Lake Crabtree Park Improvements Bid Addendum #2

Date: 08/28/2026
Wake County RFB #: 26-078
WR Project #: 22-0024-007

Notice to All Bidders:

2026.08.28 13:18:12-04'00"

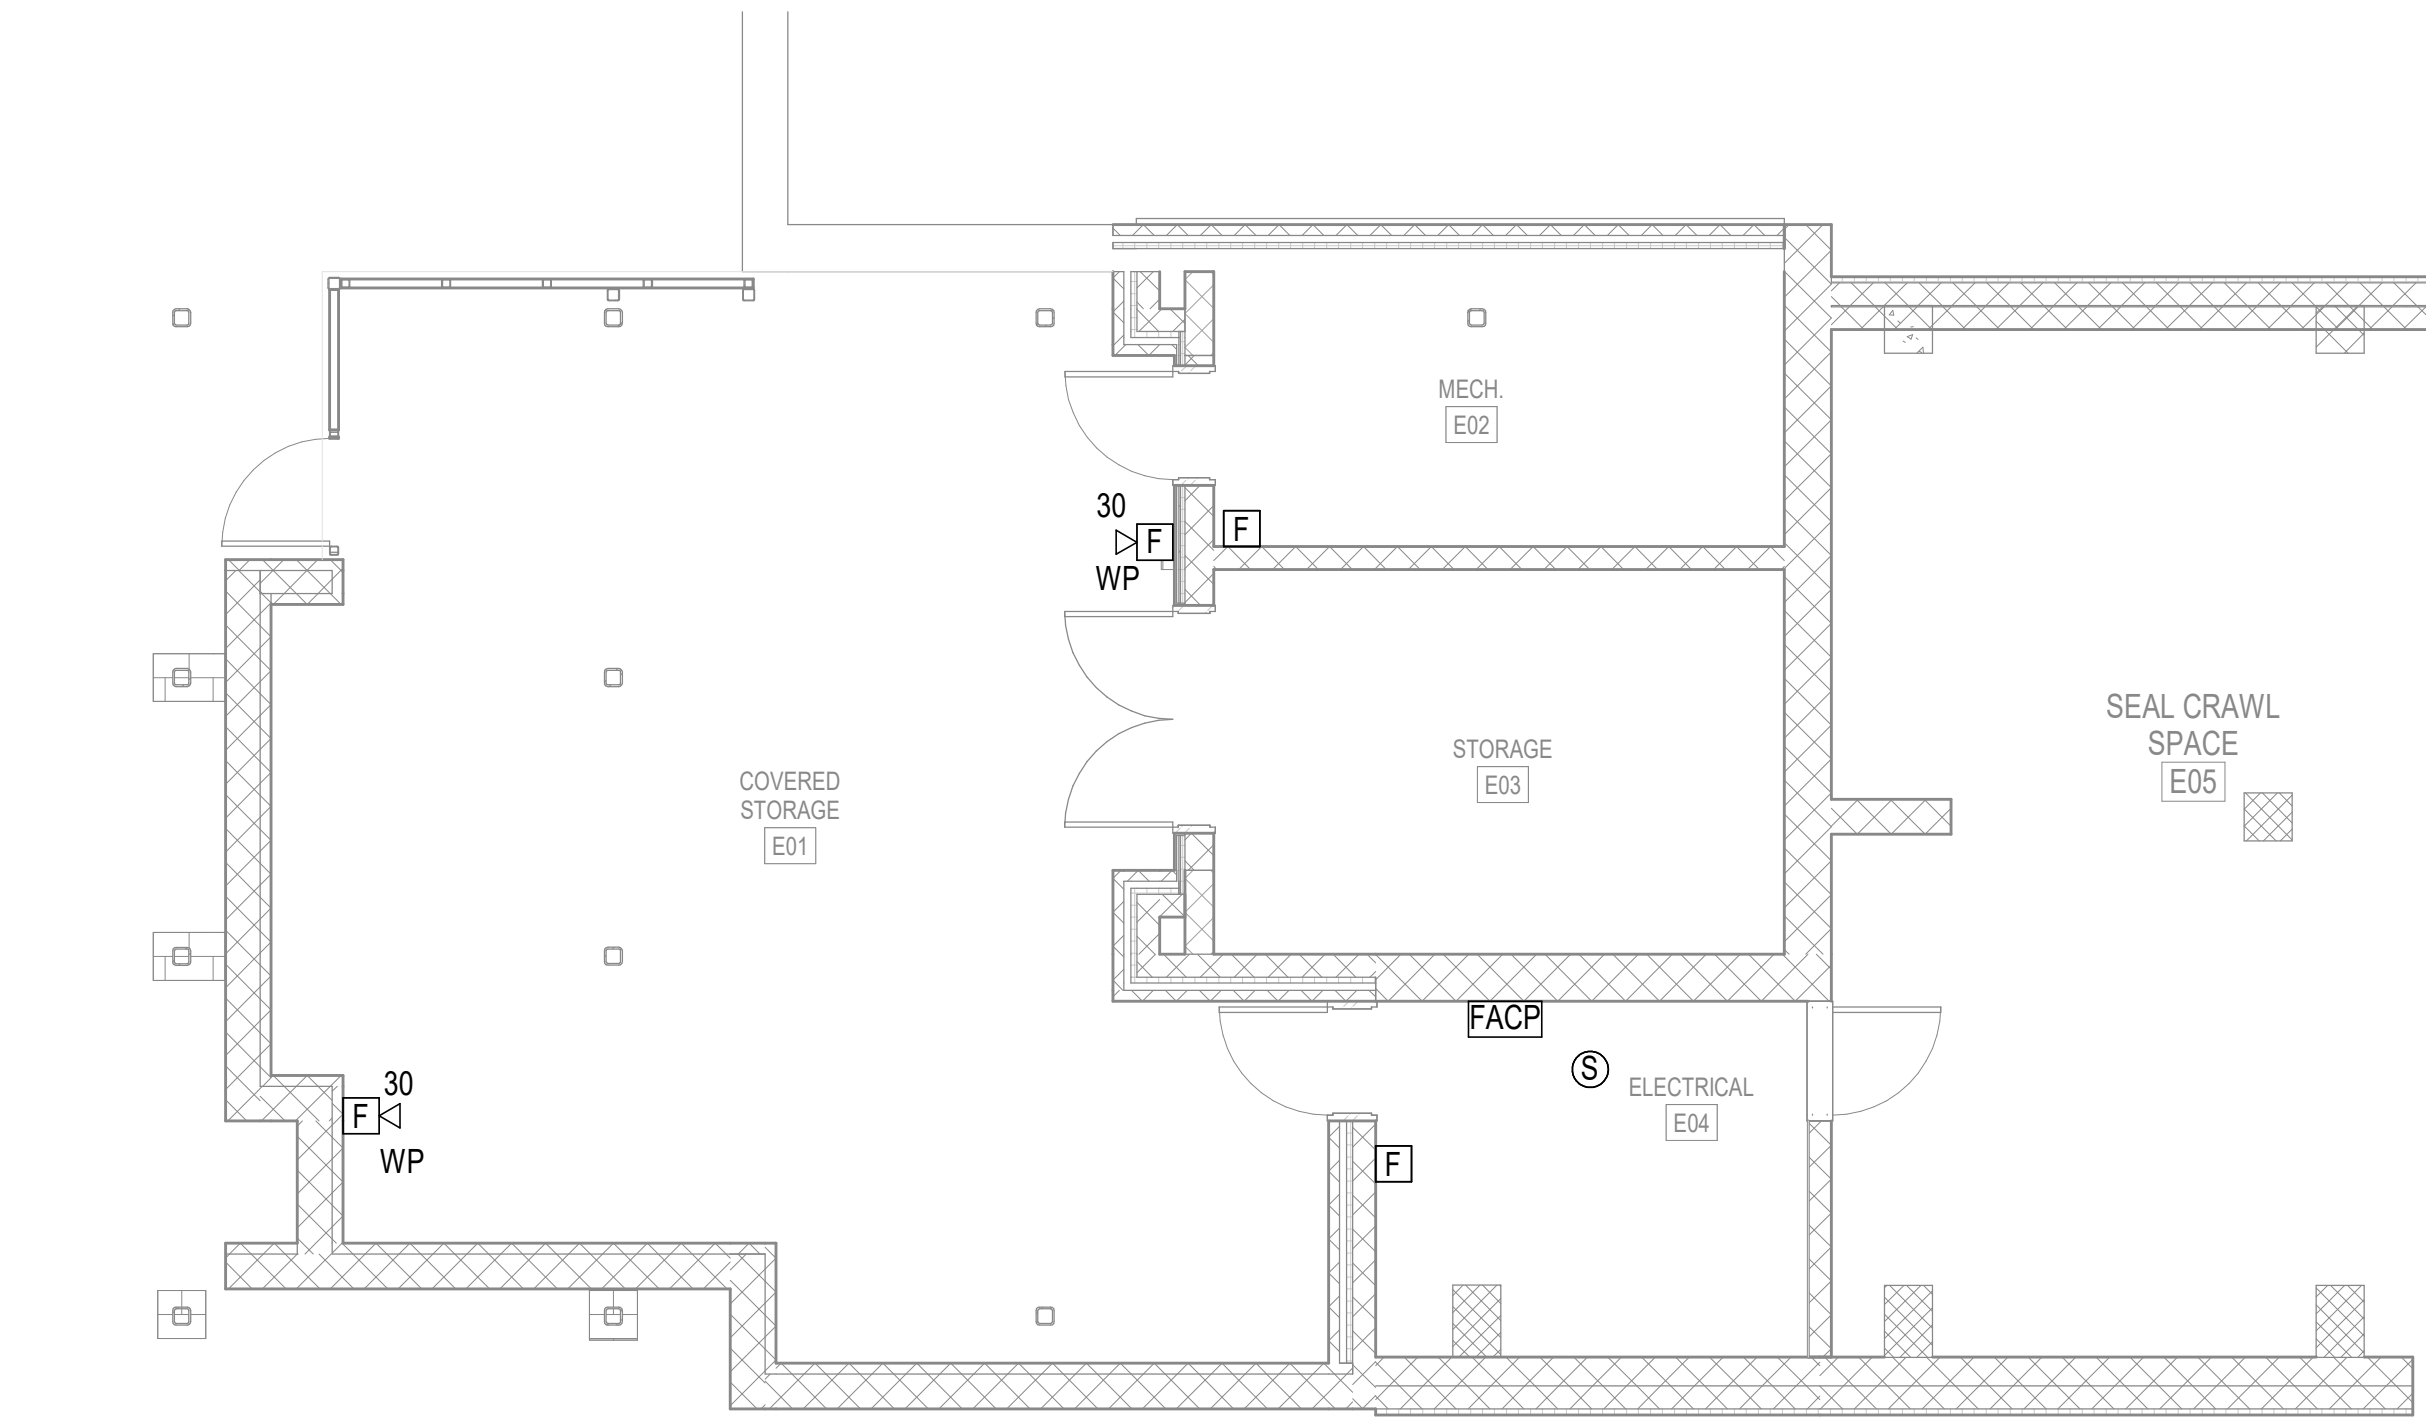
8. A2.00 - ADMIN BUILDING - DEMOLITION PLANS
 - a. KEYNOTE D17 UPDATED. GENERAL NOTE 3 OMITTED.
9. F4.11.A - EDUCATION CENTER - FIRE ALARM PLAN - ALT F-01

EDUCATION CENTER -
FIRE ALARM PLAN -
ALT F-01

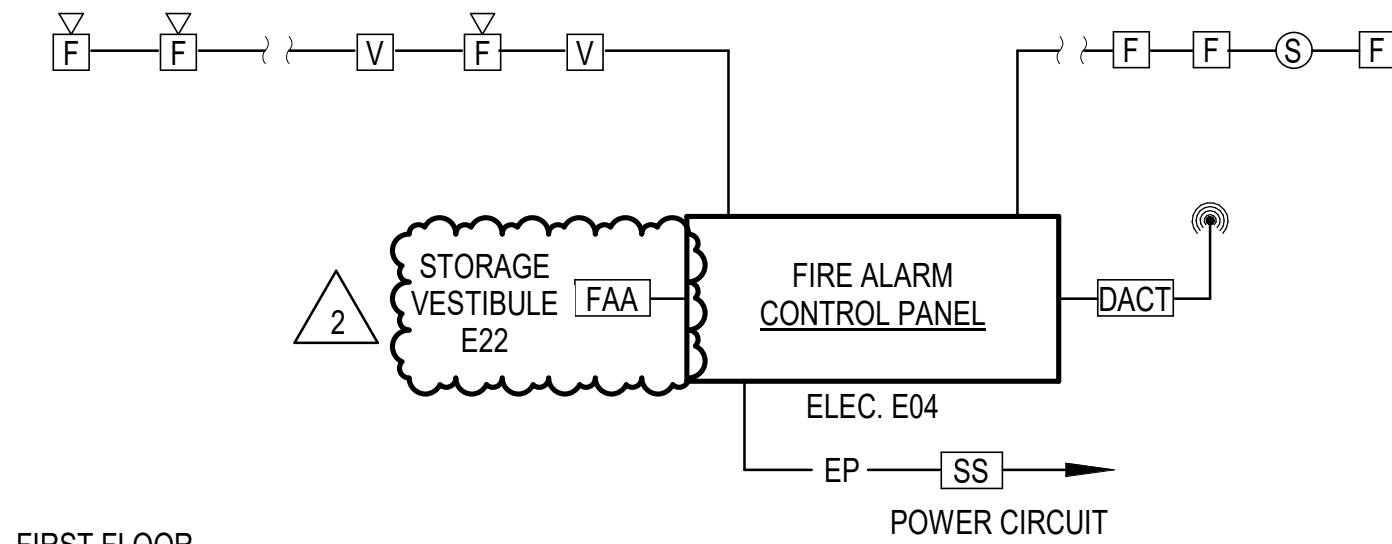
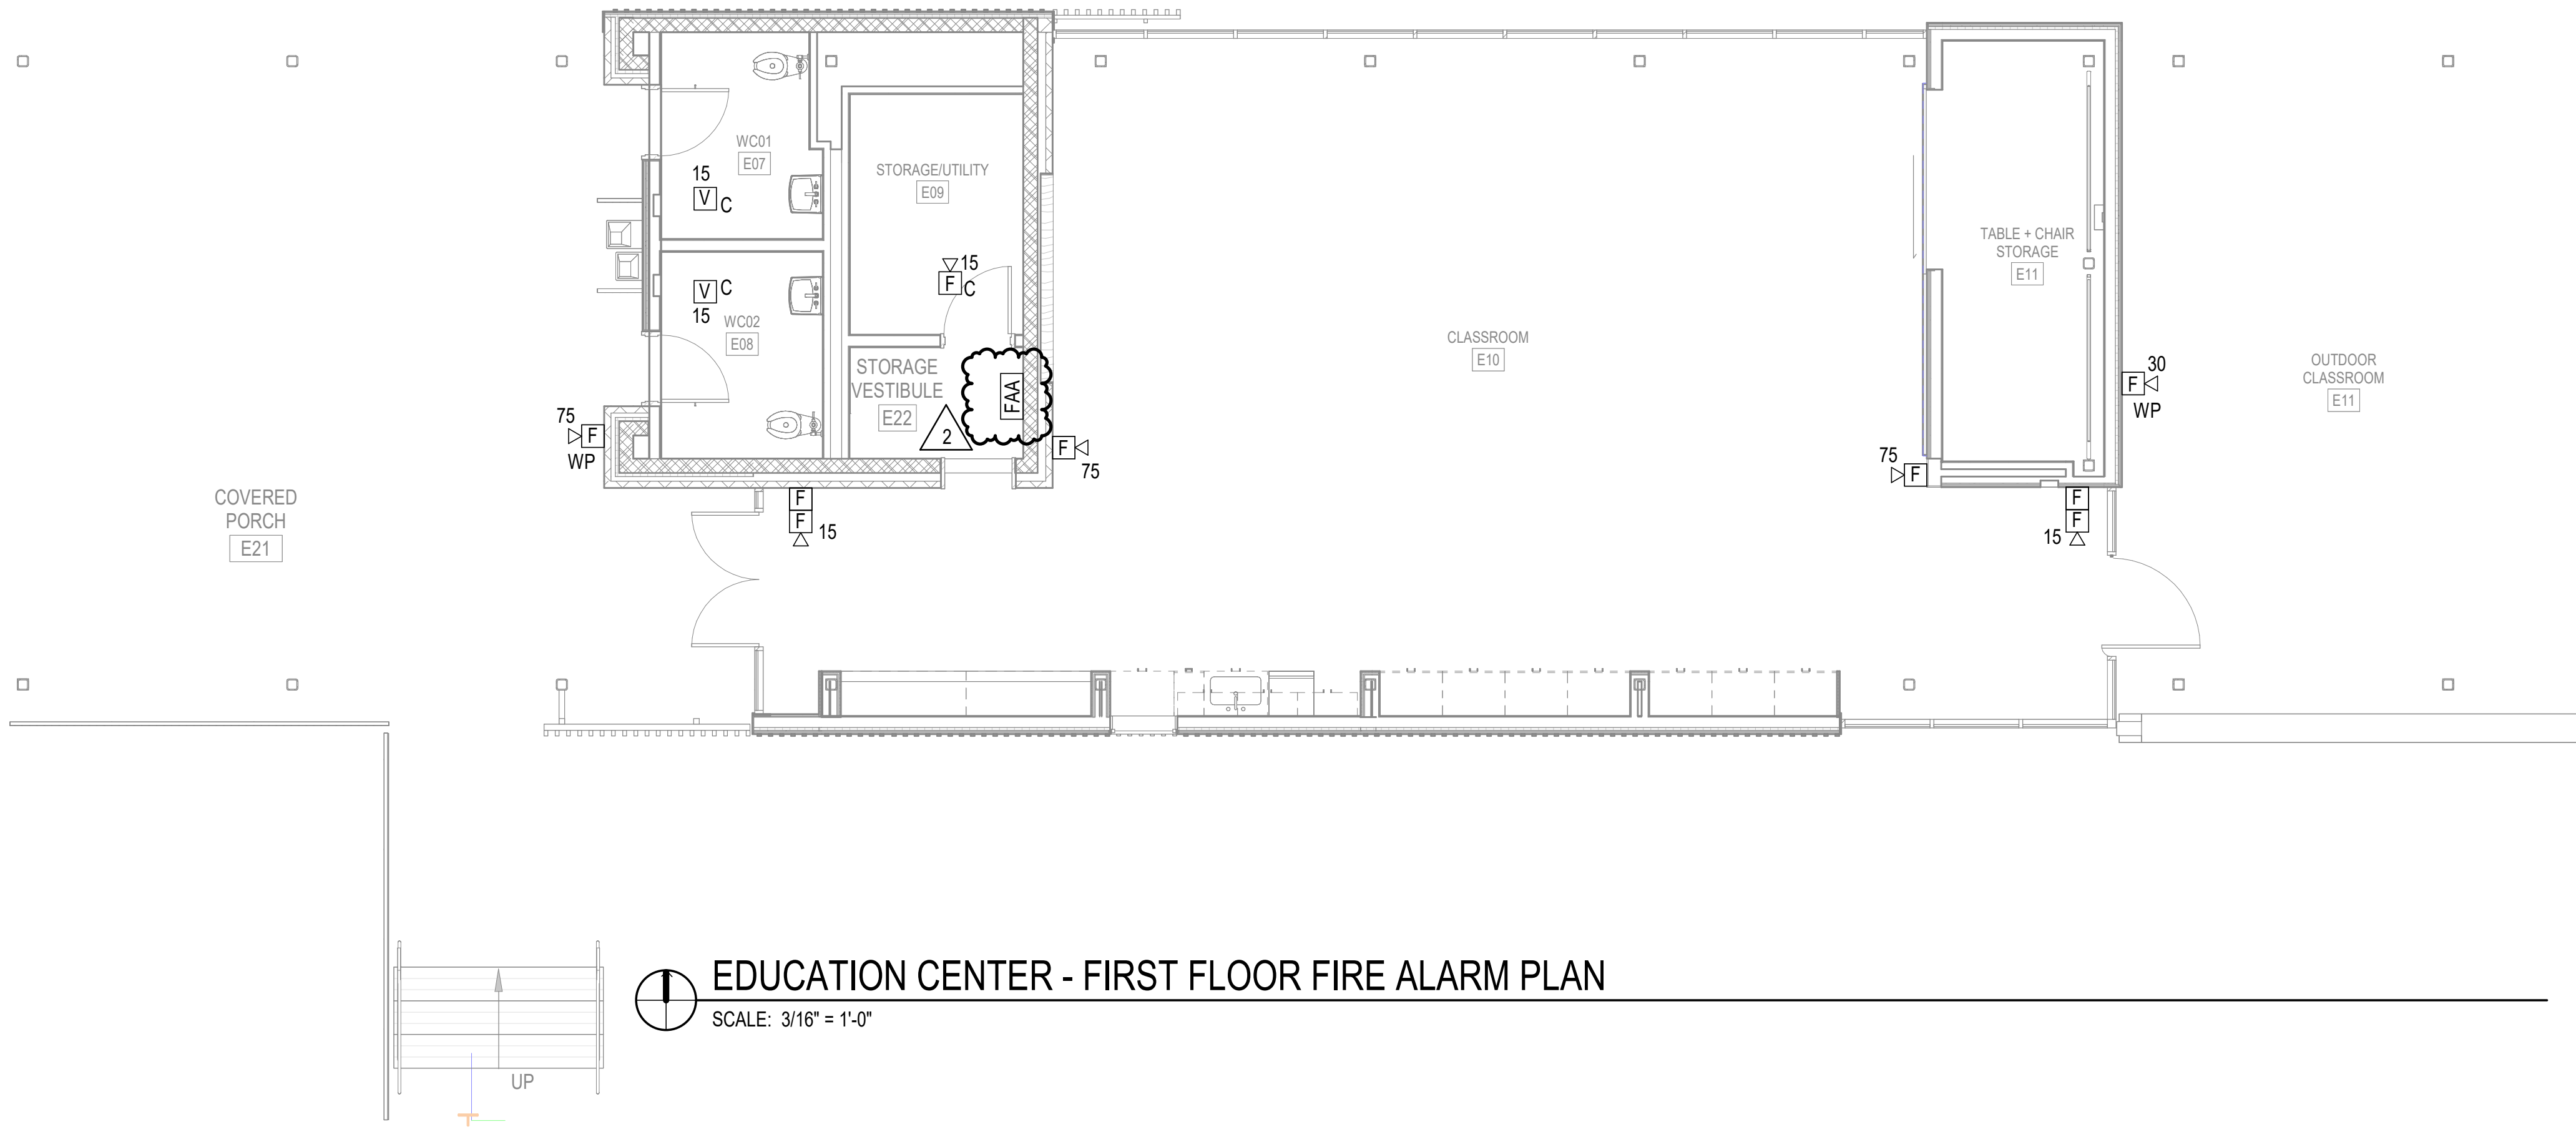
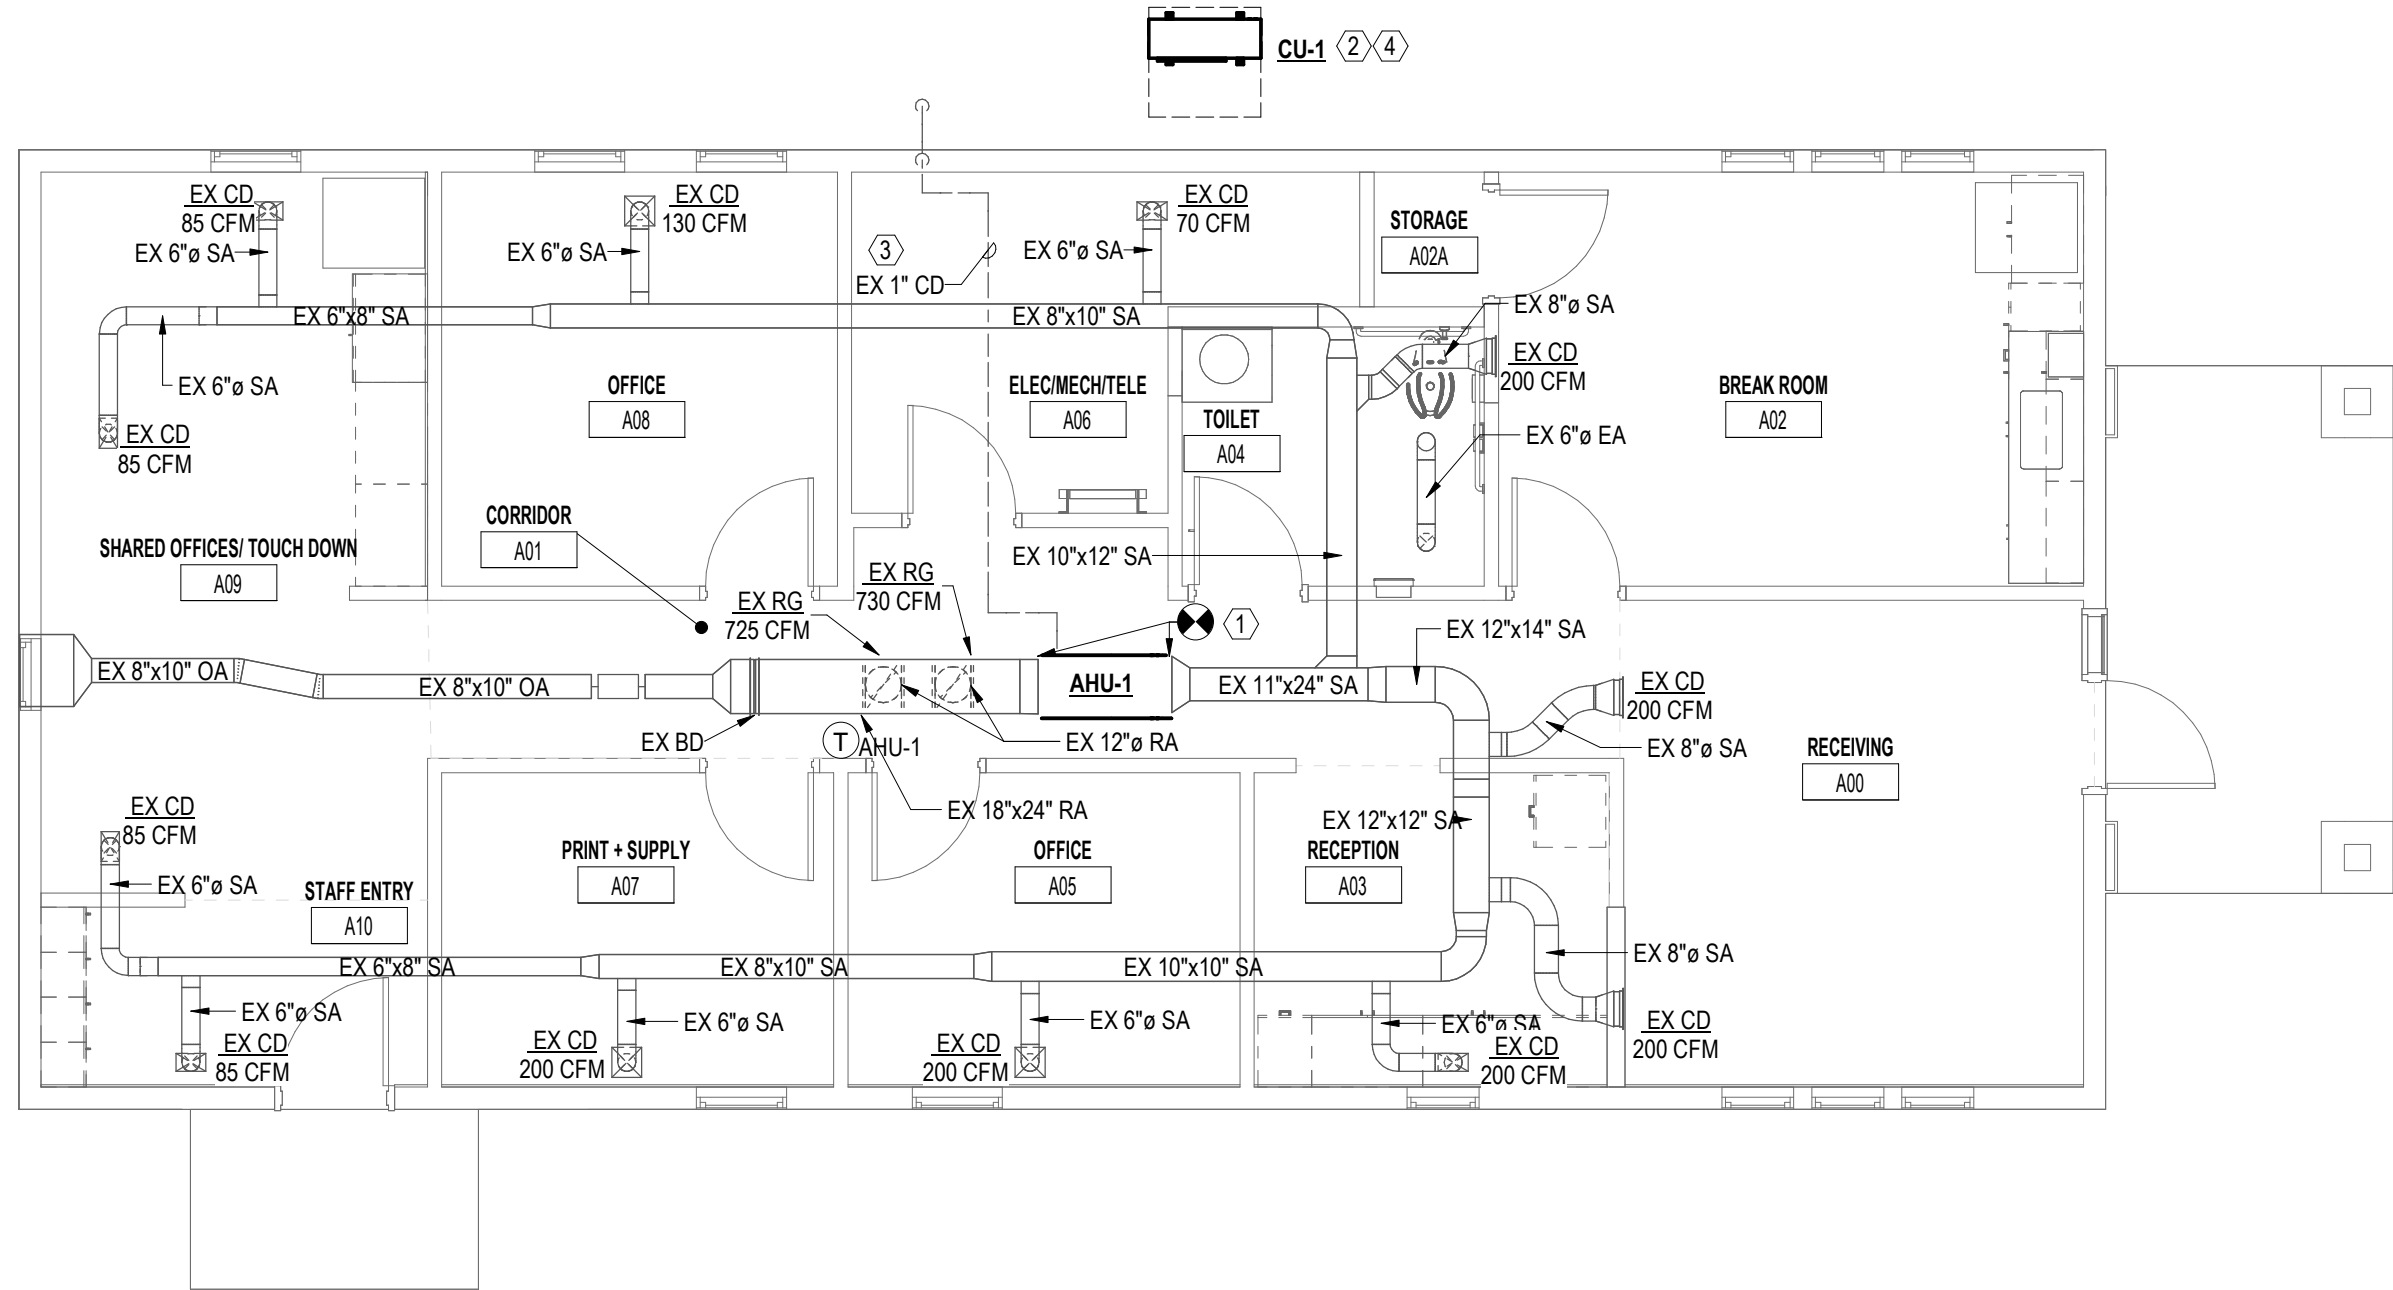
- a. REMOTE ANUNCIATOR ADDED TO LEVEL 1 WITH ACCOMPANYING DETAILS
10. M2.10 - ADMIN BUILDING - MECHANICAL PLAN
 - a. KEYNOTE 4 UPDATED
